HALTON REGION LANDFILL TECHNICAL STUDY
NOISE ANALYSIS
SITE F
SCHEDULE J-F

Prepared for
THE REGION OF HALTON

September 11, 1986

Halton Landfill - Site D - West Side
Residences - NOISE EXPOSURE

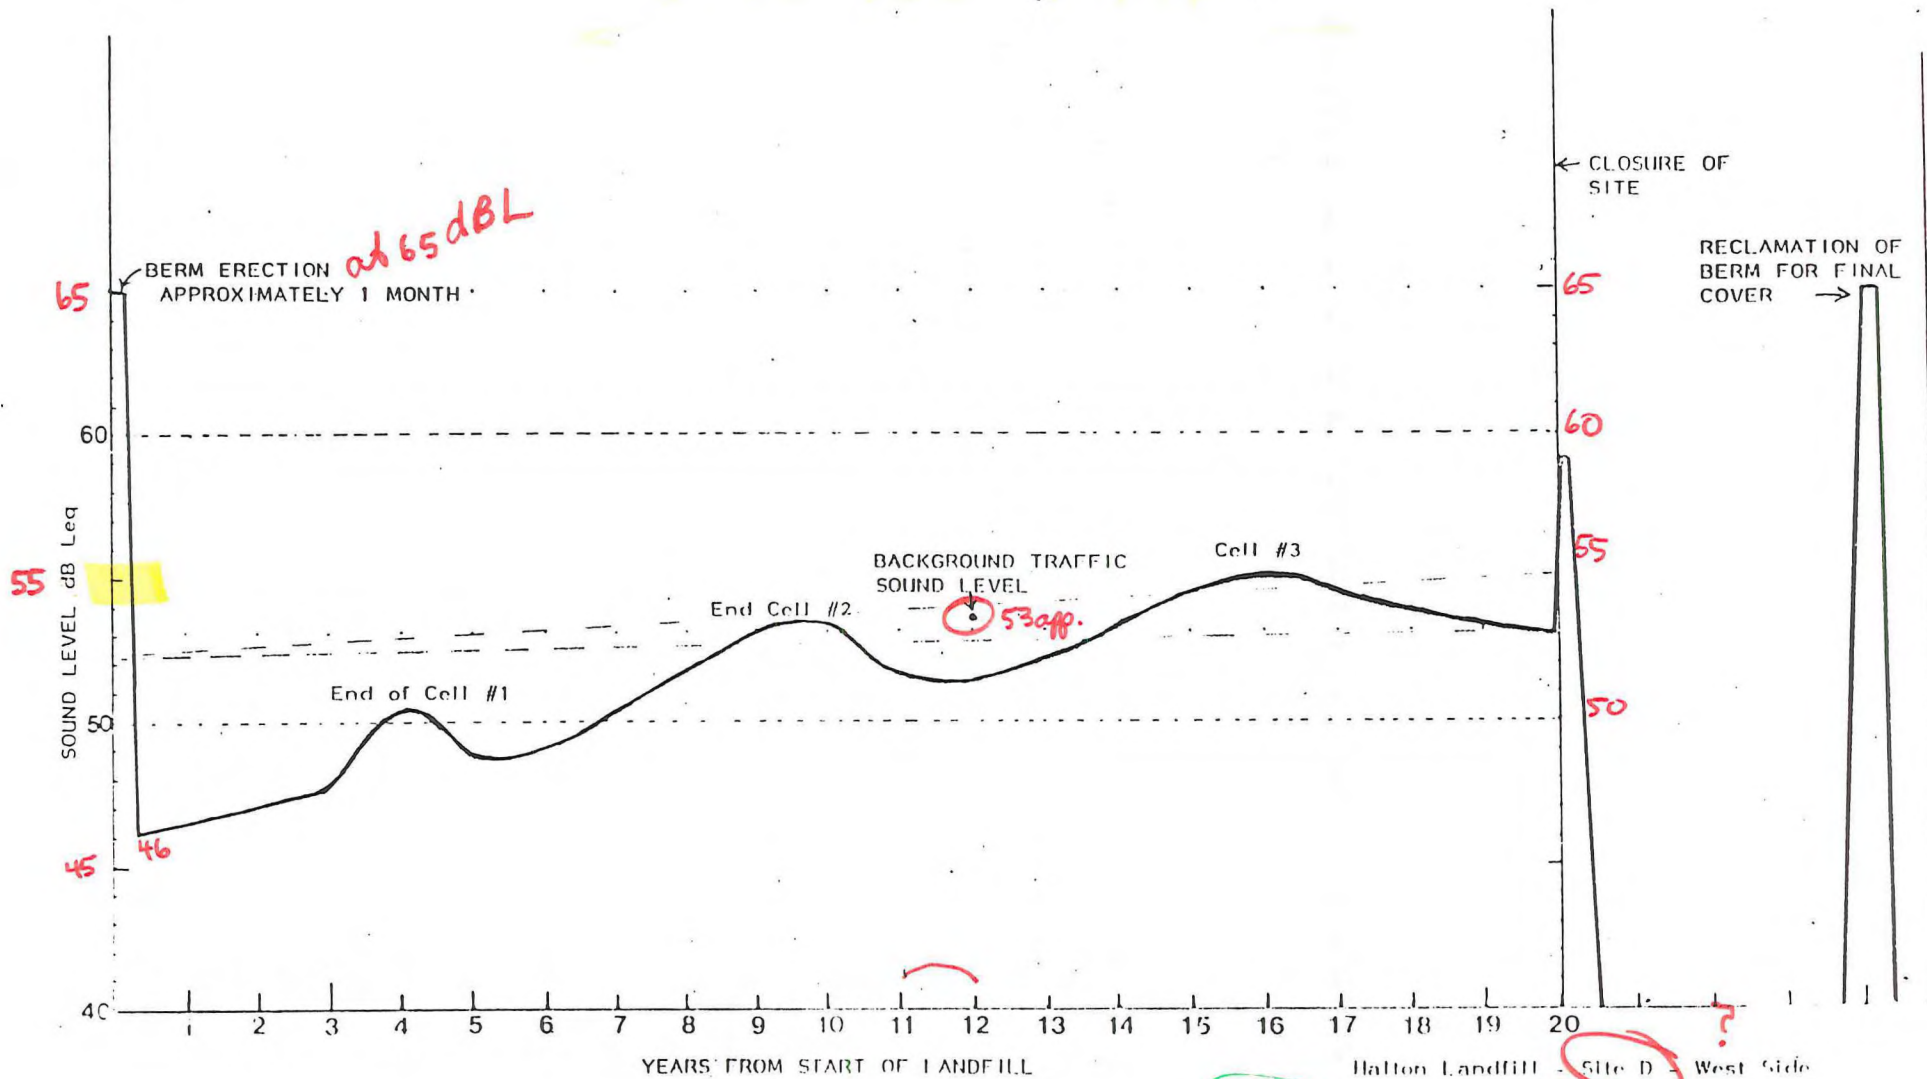
years
7 → 11

WRONG MAP
